CONTRACT ADDENDUM NO. 3

April 6, 2026

NOTICE TO ALL BIDDERS FOR THE: **Topeka & Shawnee County Public Library** Staff Spaces Renovations HTK Project No.: 2001.01-021

NOTES:
 REFER TO SECTIONS AND DETAILS ON ALL OTHER SHEETS FOR APPLICABLE NOTES NOT SHOWN.

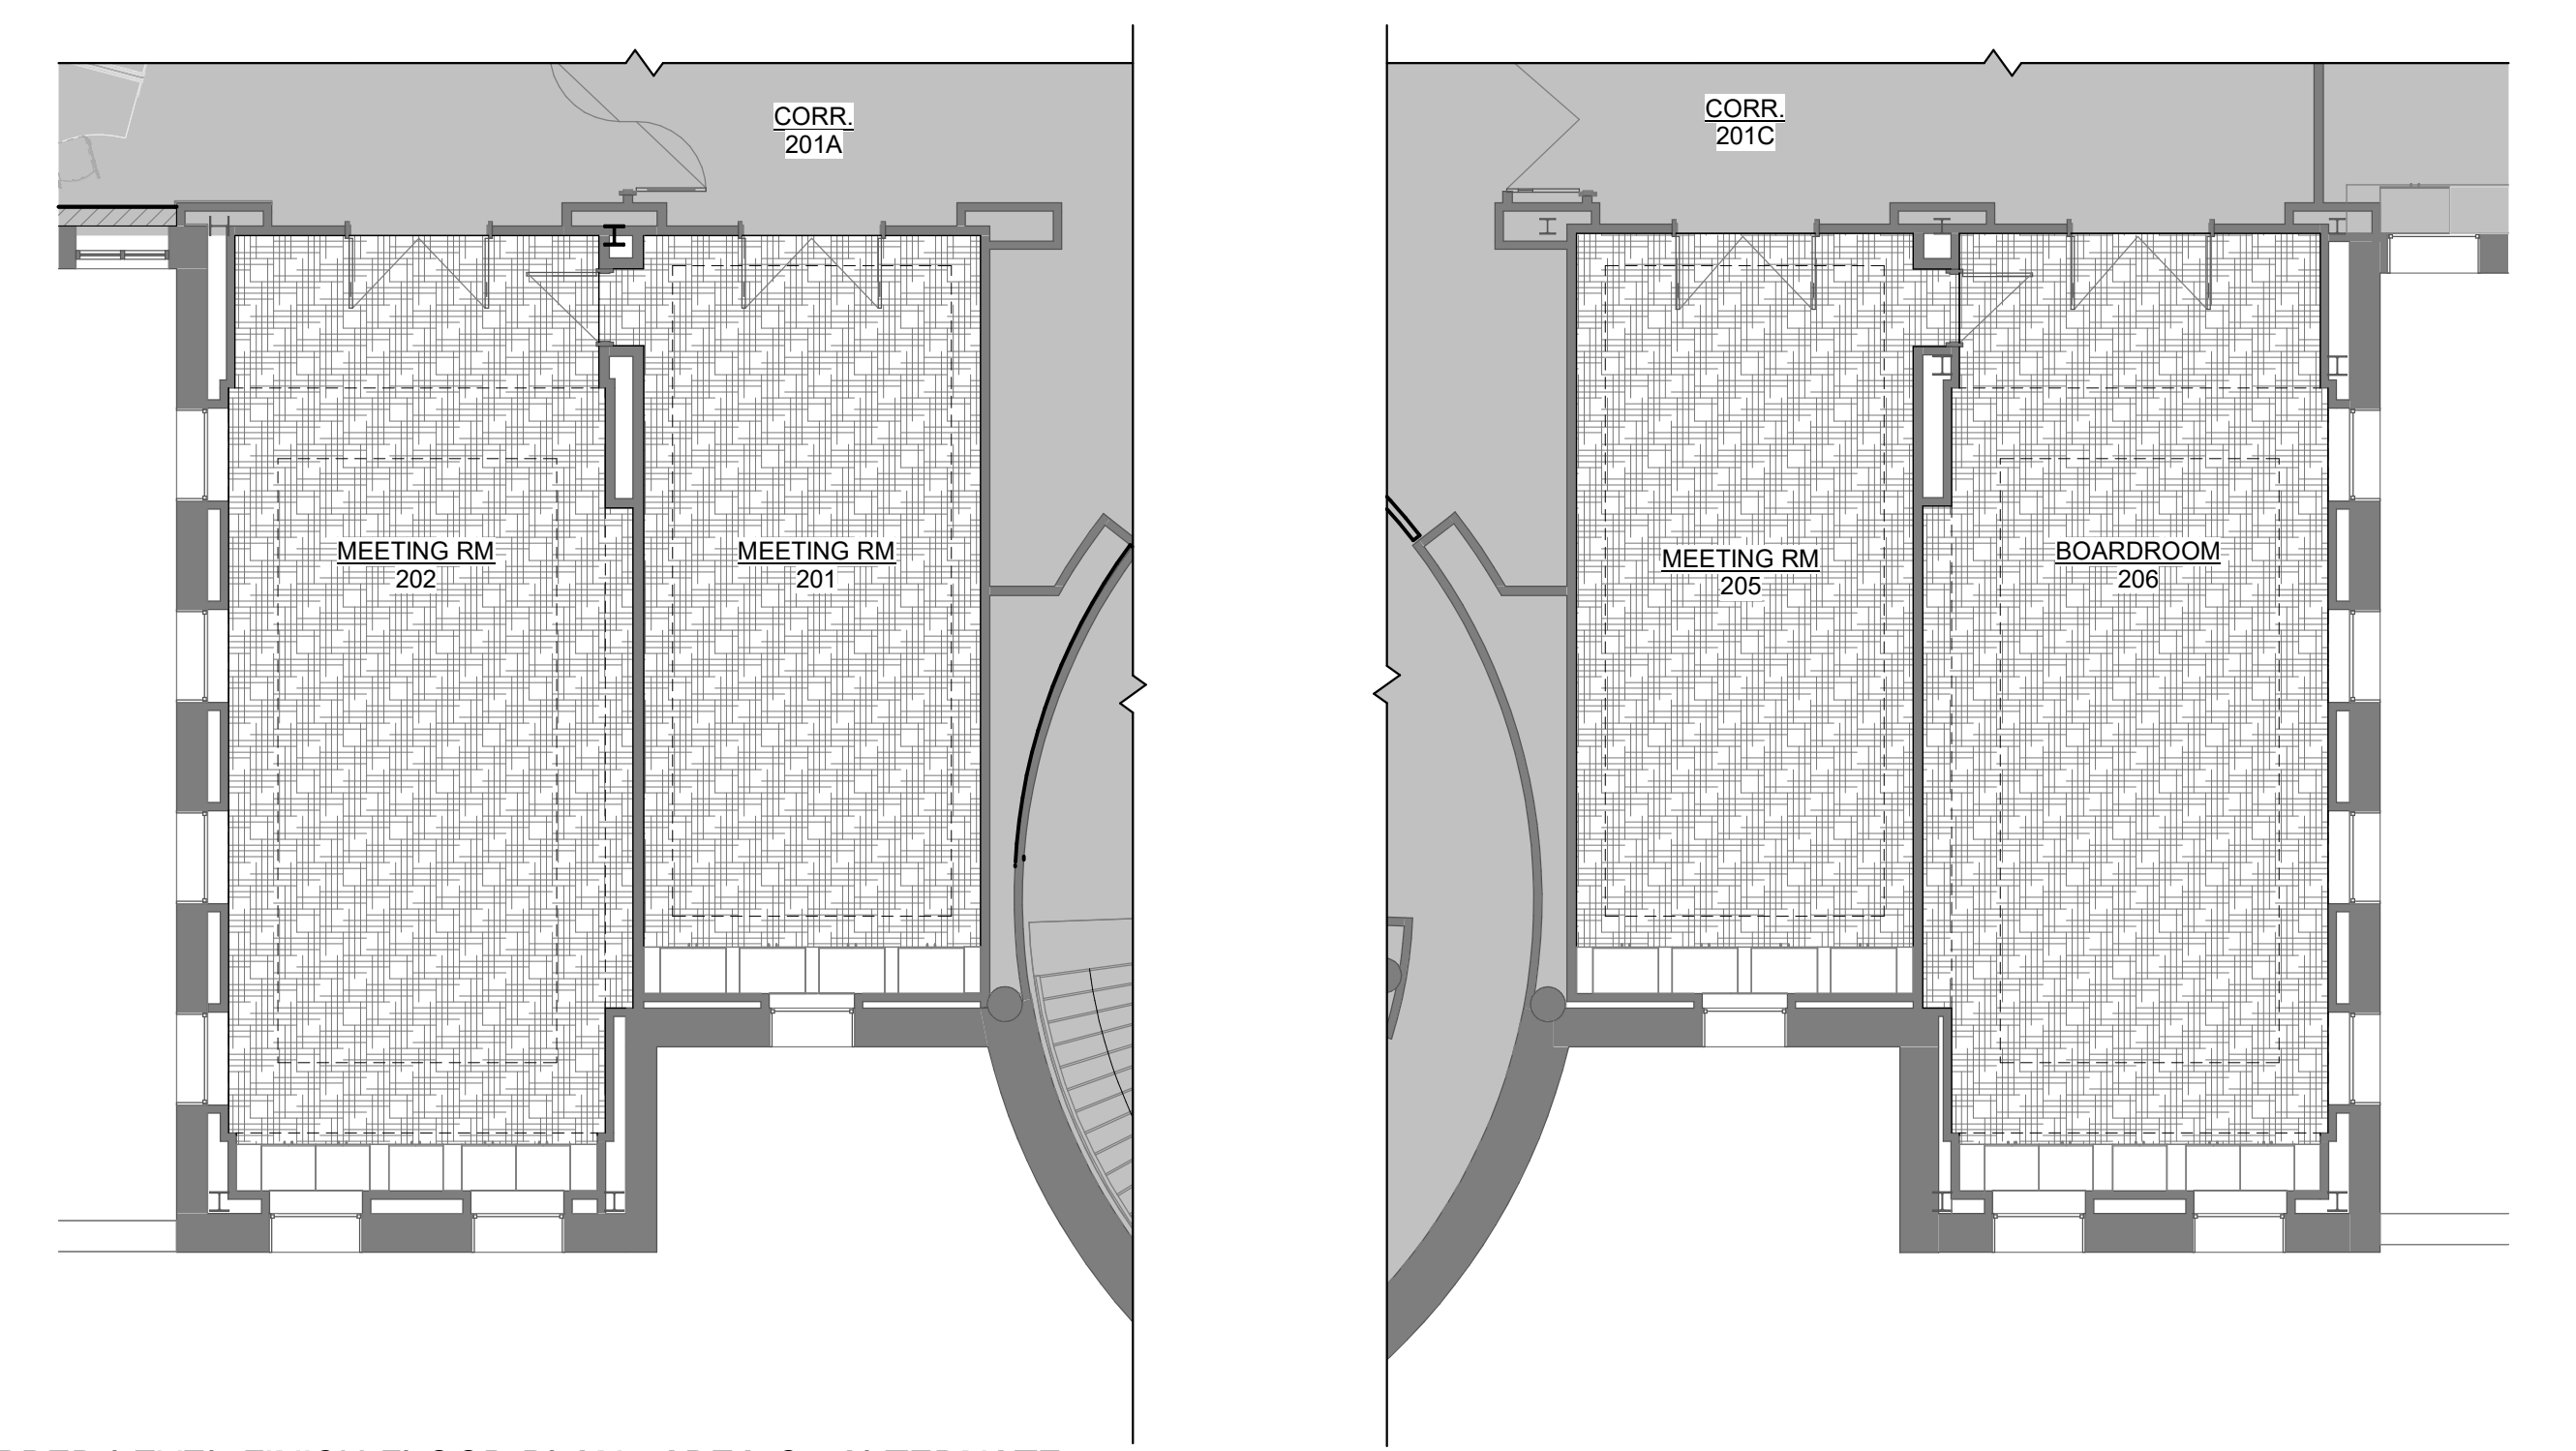
1. Provide Resilient Edge Guard between new Carpet Tile or LVT and Sealed Concrete as indicated in revised 2/A701.
2. Provide transition strips as shown on revised 1/A701.

SHEET NUMBER:
FE101

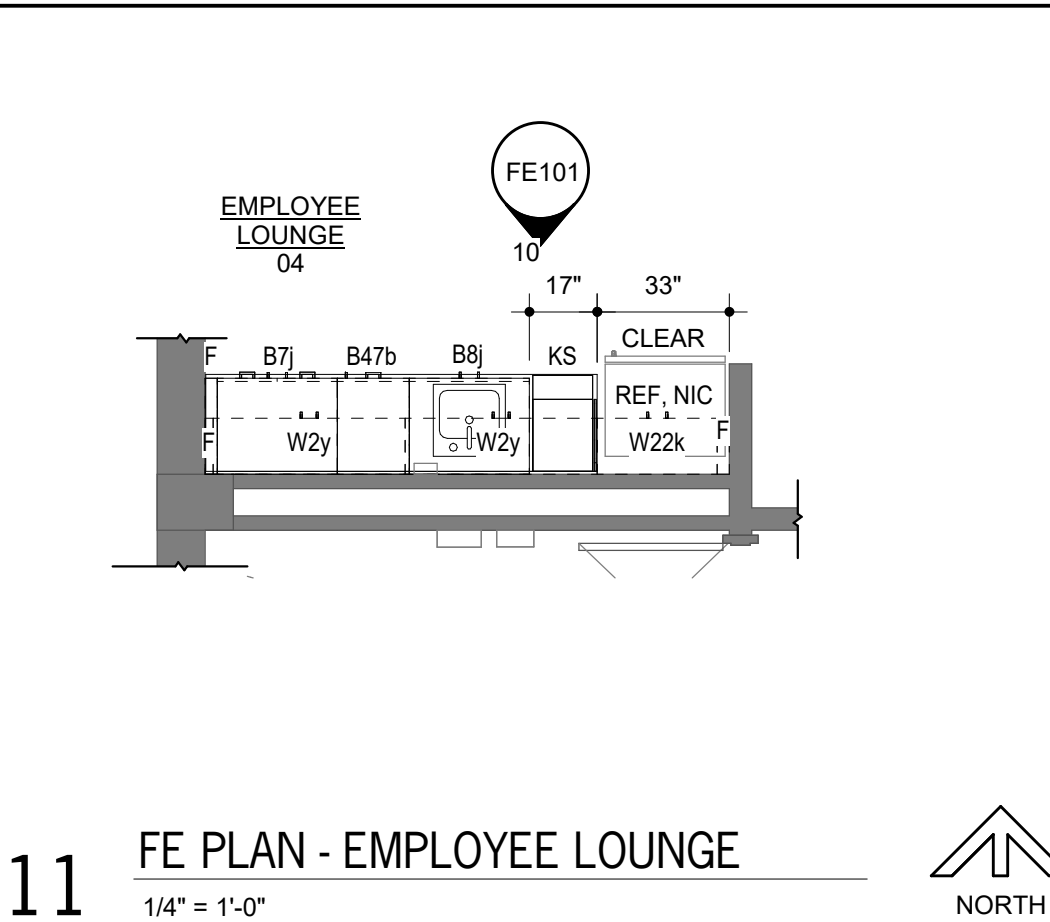
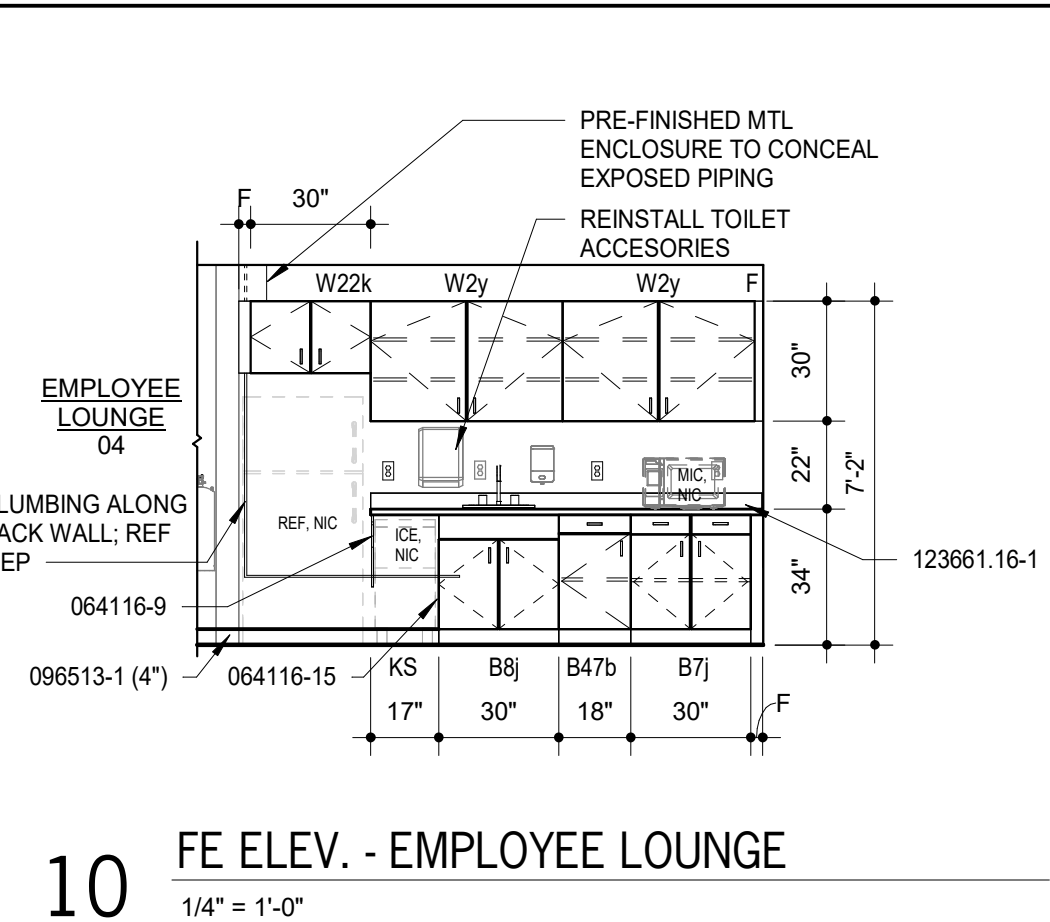
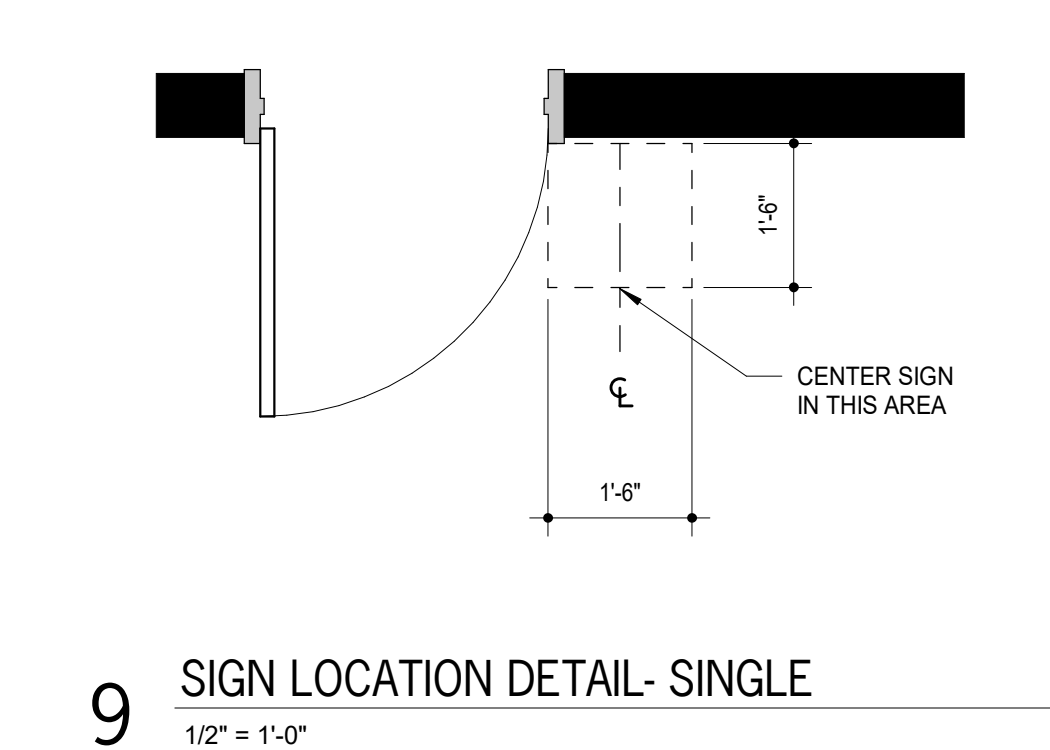
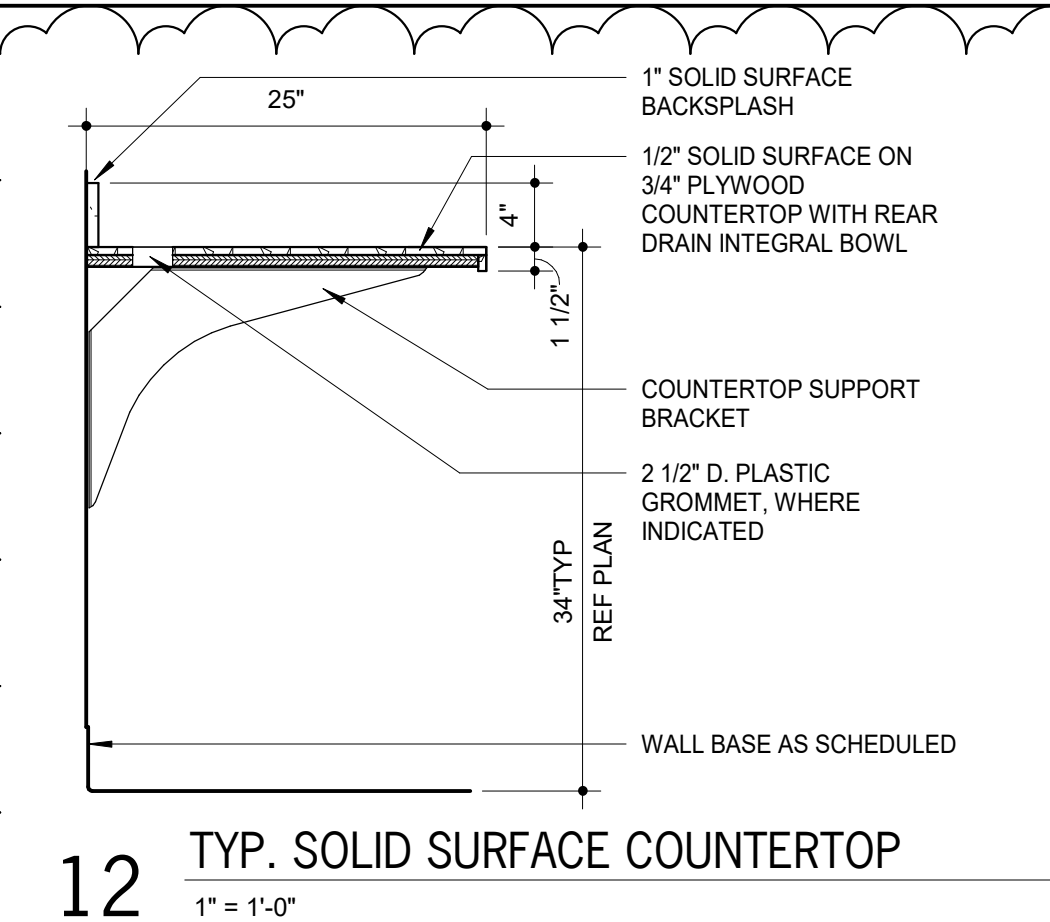
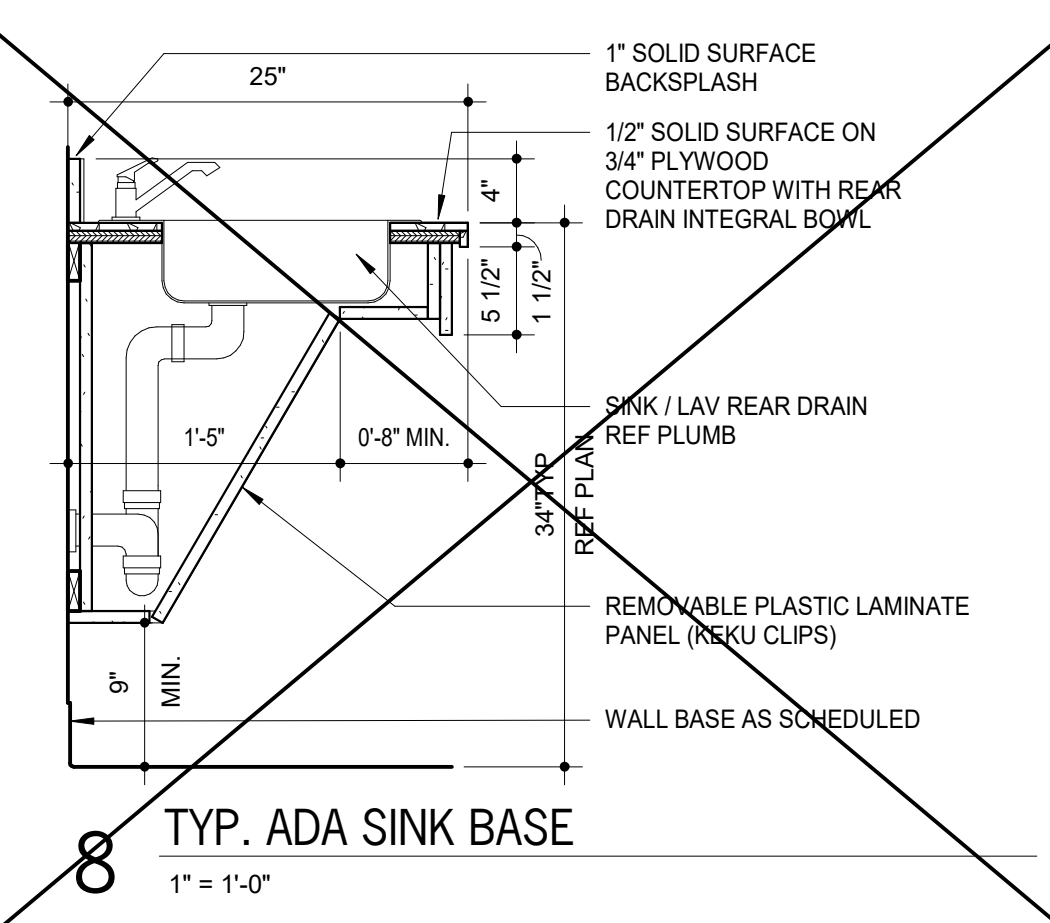
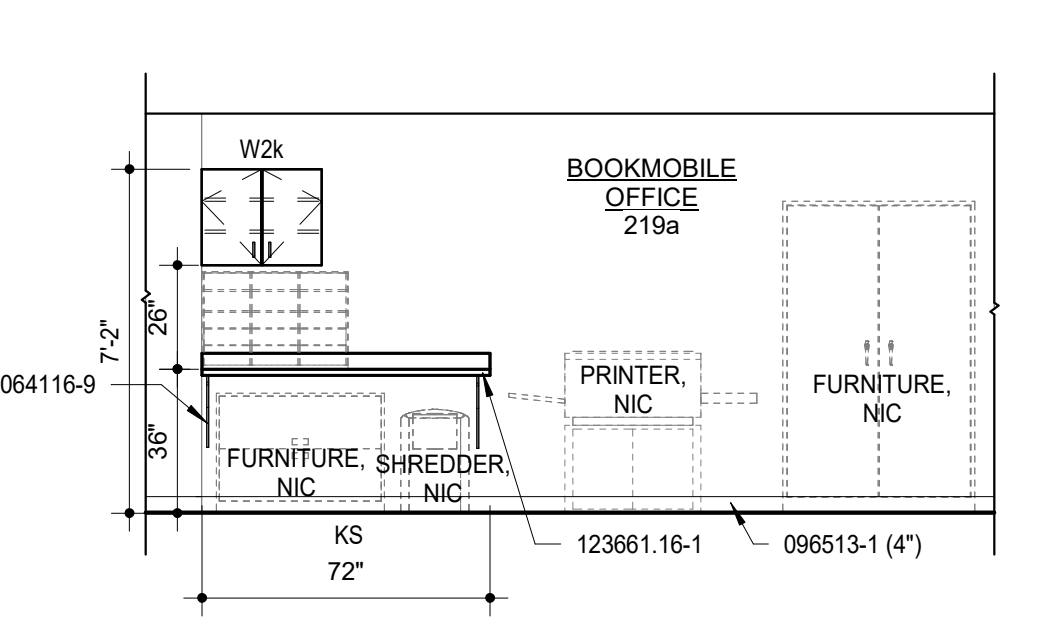
2. Q: On the Fixed Equipment elevation (FE101), the sink is shown with an ADA sink base per Detail 8. However, Views 10 and 11 on FE101 indicate a lower cabinet type B8j beneath the sink. Please confirm which cabinet base is intended for the sink in the Employee Lounge.
A: *Cabinet type B8j shall be provided at the Employee Lounge.*

1. Revise: View 8/FE101 is not used in the project.
2. Add: View 12/FE101 clarifying the fabrication of typical solid surface countertops at all locations within project.
